**CHABOT-LAS POSITAS  
COMMUNITY COLLEGE DISTRICT  
PURCHASING DEPARTMENT**

**Addendum No. 4  
INVITATION TO BID No.: B20/21-08  
Agriculture Science, Horticulture Facility Project**

CLPCCD - LAS POSITAS COLLEGE  
**AGRICULTURE SCIENCE HORTICULTURE FACILITY**  
3000 CAMPUS HILL DRIVE,  
LIVERMORE, CA 94551

**EA141**

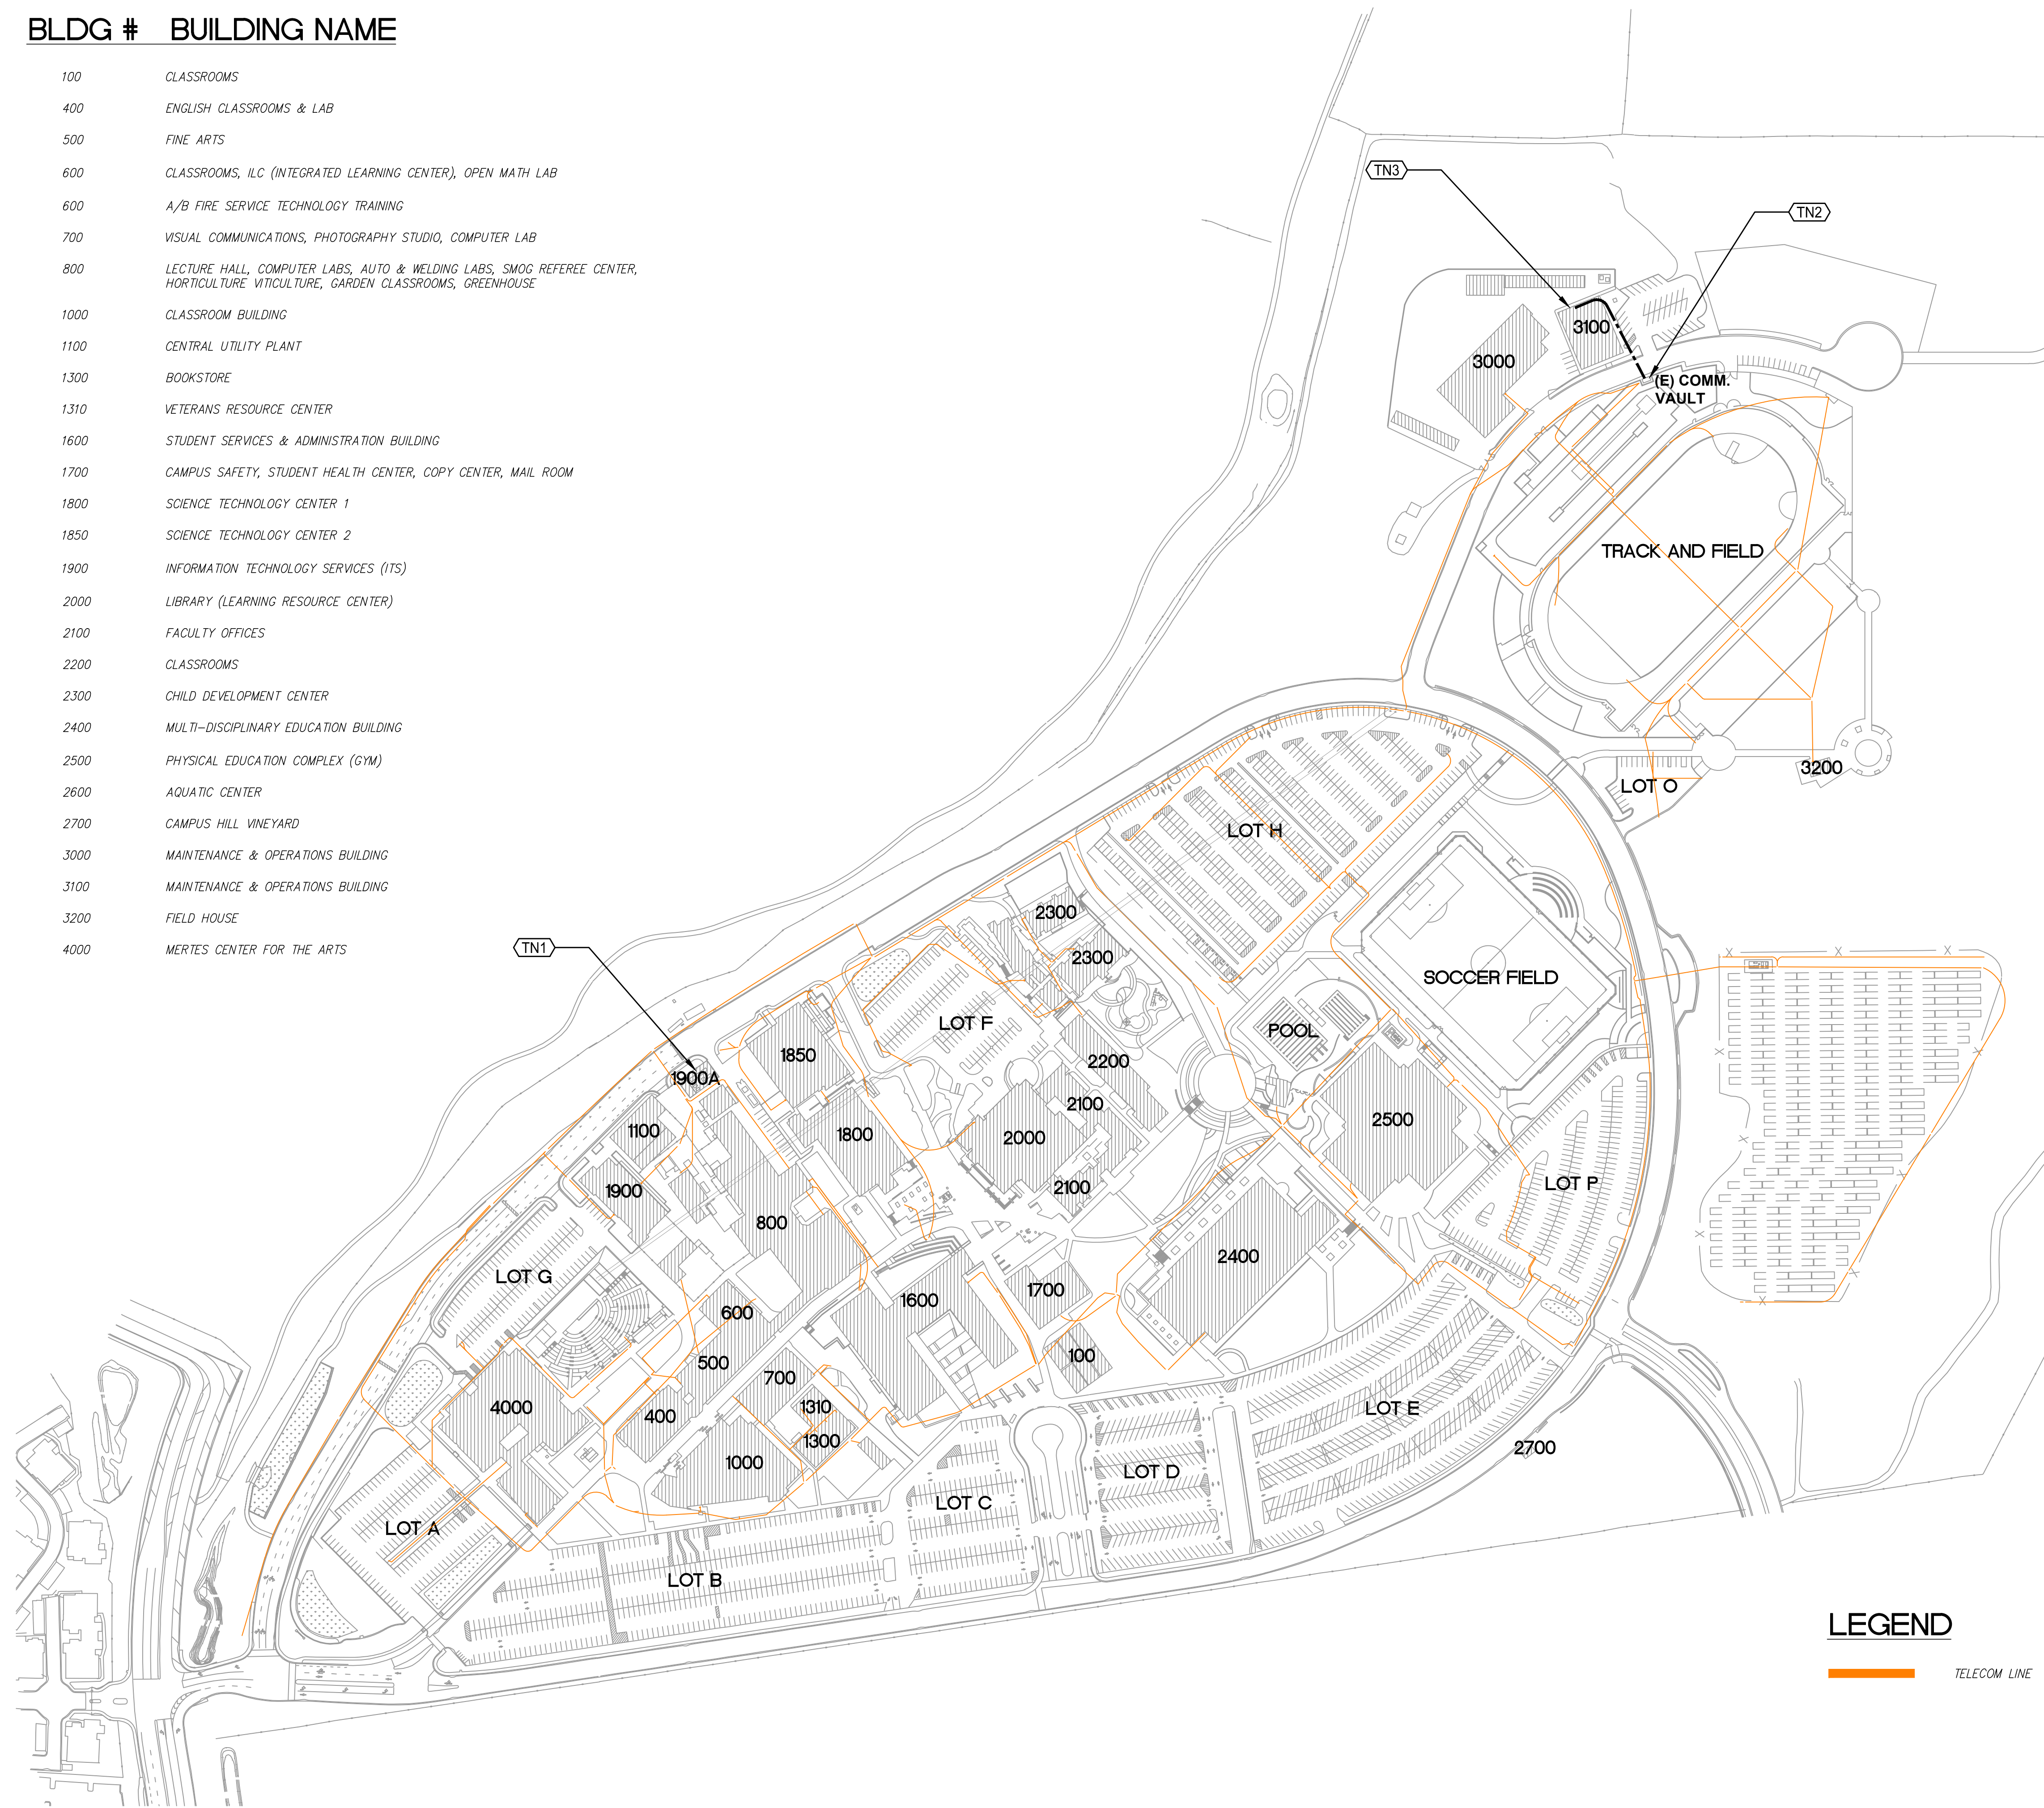
- a. Updated Door Schedule.
    - b. Added EE door type elevation.
  11. **Sheet EA141 – Classroom Building Floor Plan Lighting:**
    - a. Added exit light.

- b. Updated alignment of undercounter lighting.
    - c. Deleted stray circuit lines.
  12. **Sheet TA100 – Telecom System Diagram:** Revised Keynote TN3 from Single Mode Fiber to Multimode Fiber.

# TA101

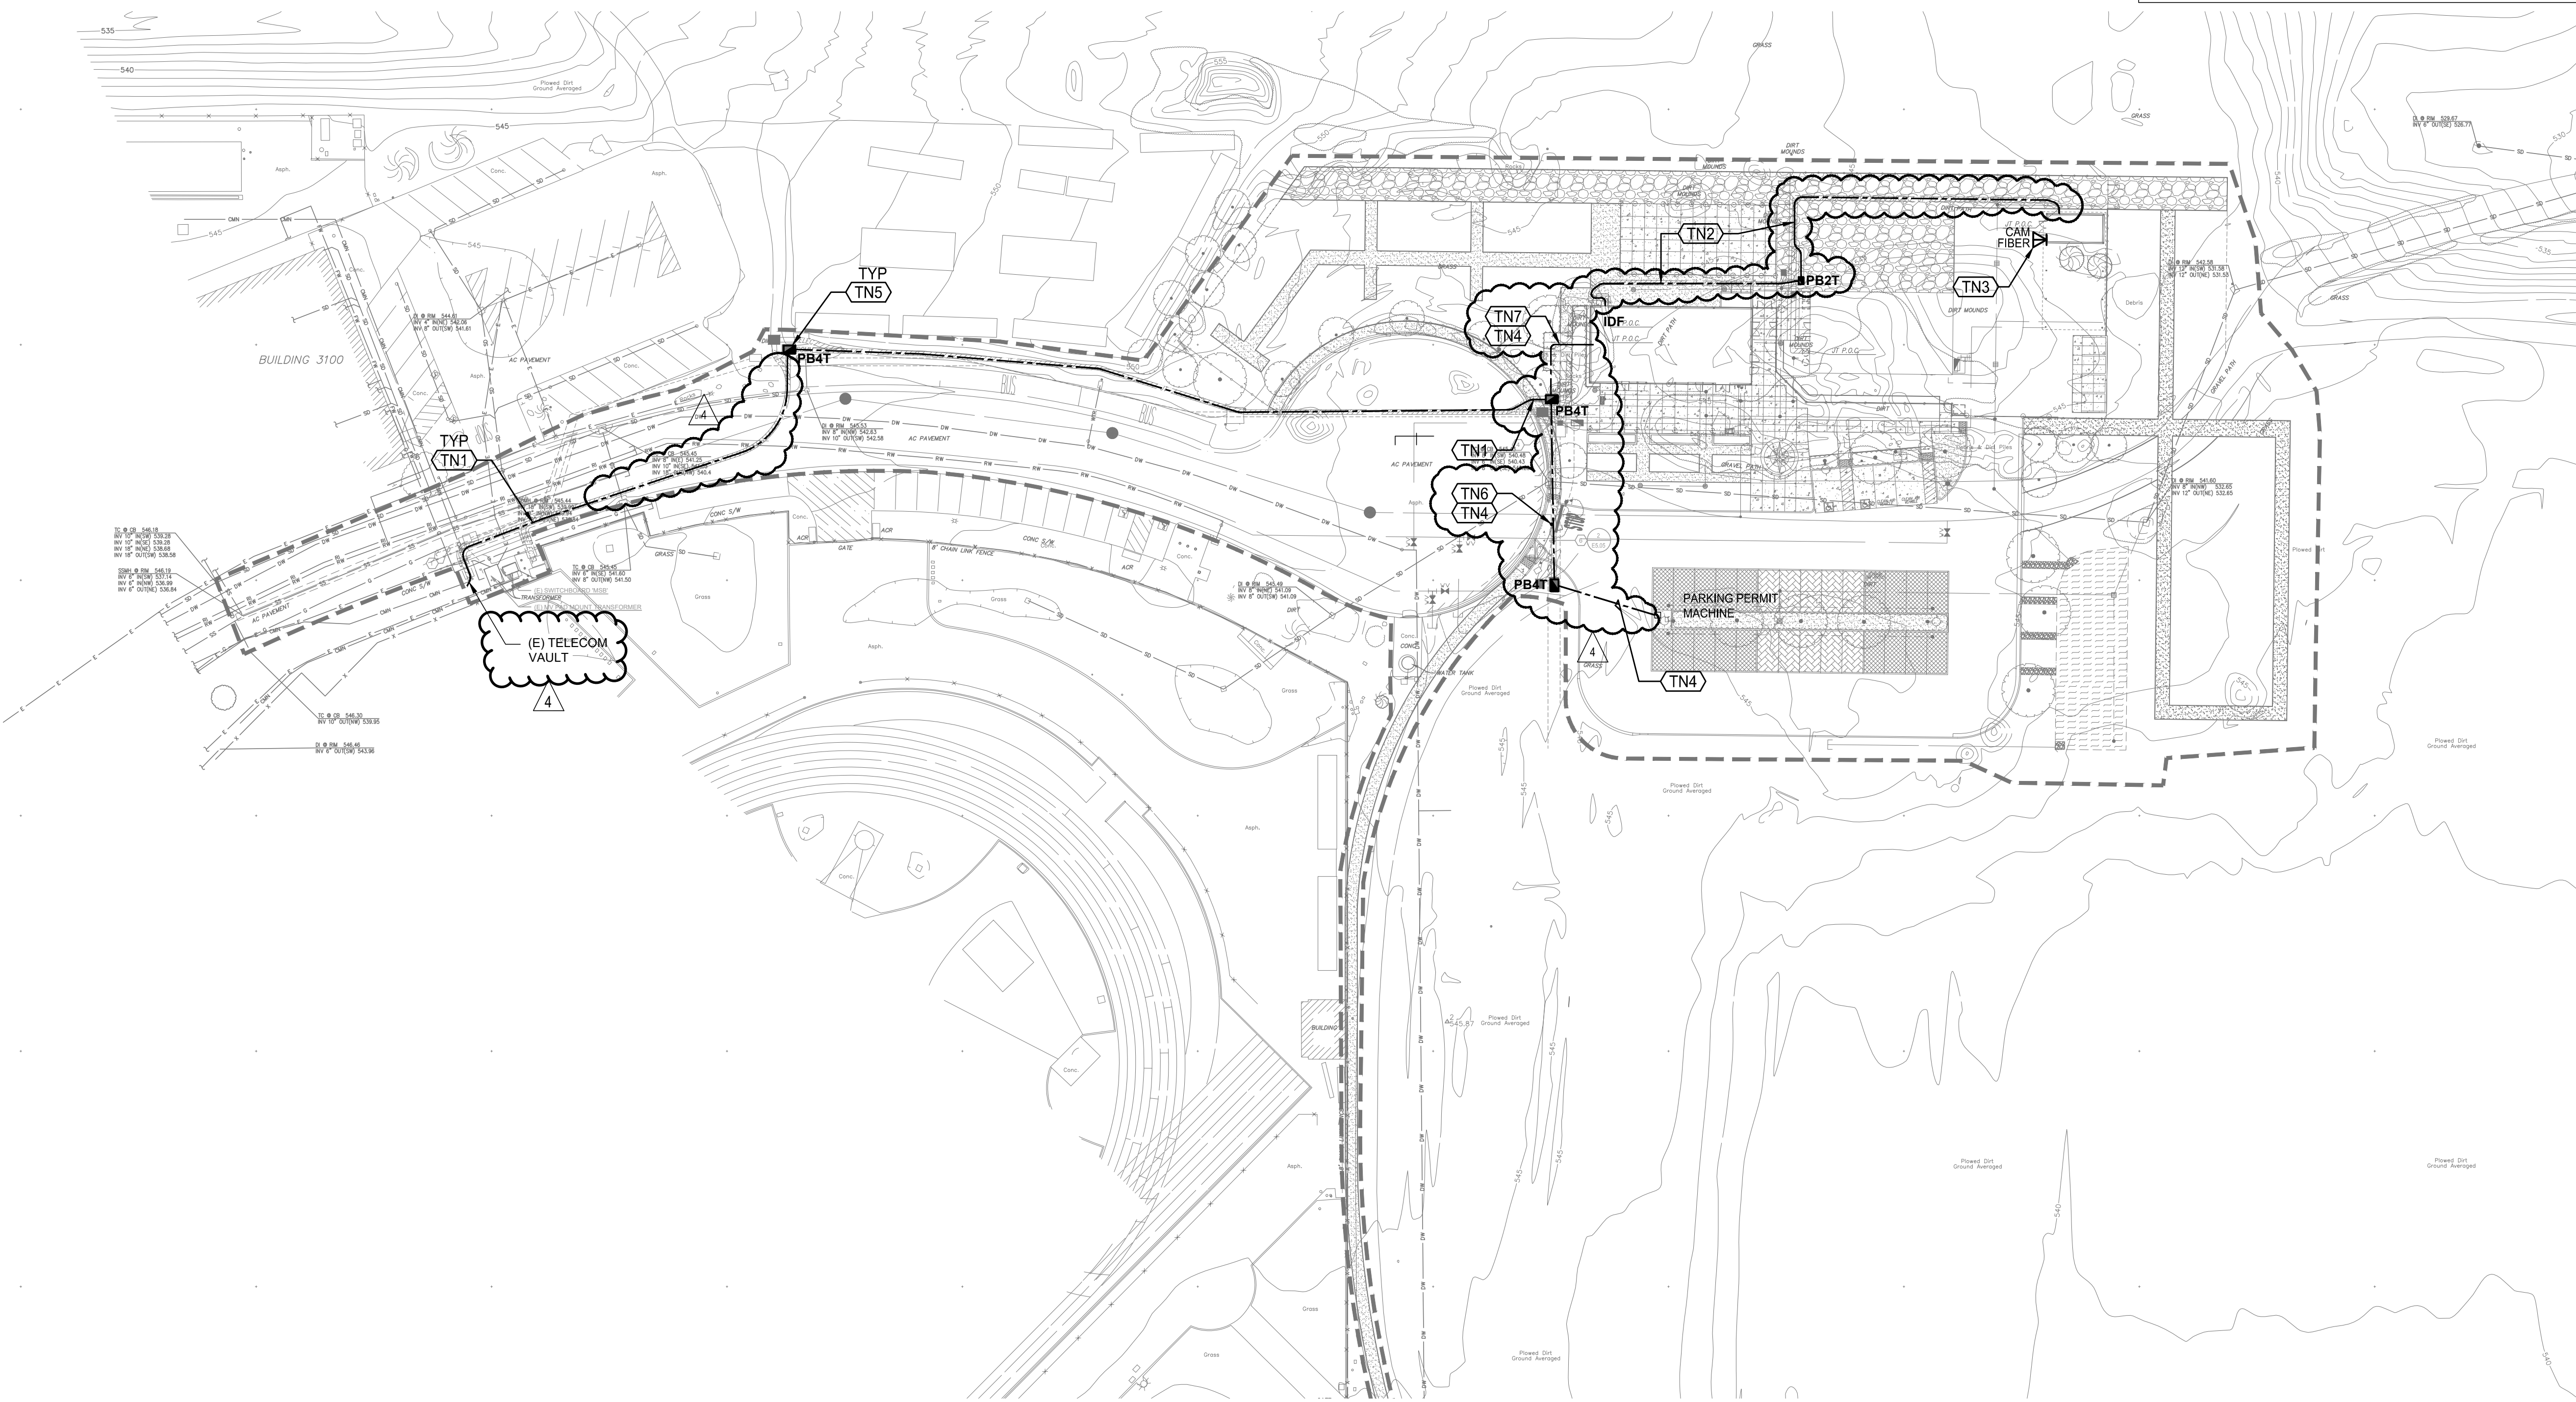
13. **Sheet TA101 – Telecom Site Plan:**
    - a. Updated conduit route.
    - b. Revised Keynote TN1.
    - c. Added Keynotes TN5, TN6 and TN 7.
  14. **Sheet TA401 – IDF Room 107A Enlarged Plans and Elevations:**
-
